| 8802-3/802.3 REVISION REQUEST 1167 |

REQUESTED REVISION:
STANDARD: IEEE Std. 802.3af-2003
CLAUSE NUMBER: Figure 33-6
CLAUSE TITLE: PSE State diagram

Figure 33-6—PSE state diagram

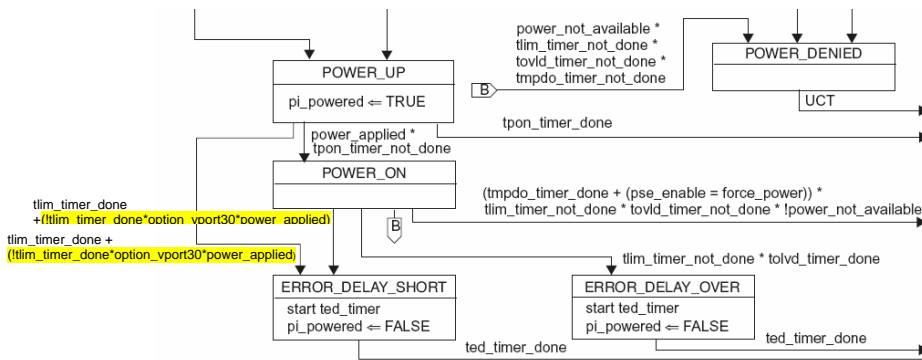
Add new variable option_vport30 to 33.2.3.4. It will be an optional variable. Change state diagram (figure 33-6) per the attached drawing.

The state diagram allows a scenario that violates the minimum requirement of Ted as specified in table 33-5 item 21 when PSE-PD motor-boating or oscillates with high peak power during short circuit condition.

During short circuit condition, PD input voltage is dropping below Voff=30V (table 33-12 item 8) the PD enters to its OFF mode and the PD input capacitor is discharged partially or completely pending the short circuit condition duration.

Now the current is very low so the PSE voltage is going high again and when crosses the PD Von value (30V to 42) it charge the PD capacitor again by drawing Iinrush.

The PSE voltage will drop again below Voff of the PD (30V) and the process will be repeated until TLIM is done.

In order to handle this scenario, we need to allow to shut the PSE port if Vport is below a value that cause PD to be at OFF.

Using this optional variable in the state diagram will fix the problem by changing the inputs to ERROR_DELAY_SHORT state from: tlim_timer_done to: Tlim_timer_done + !tlim_timer_done*option_vport30*power_applied
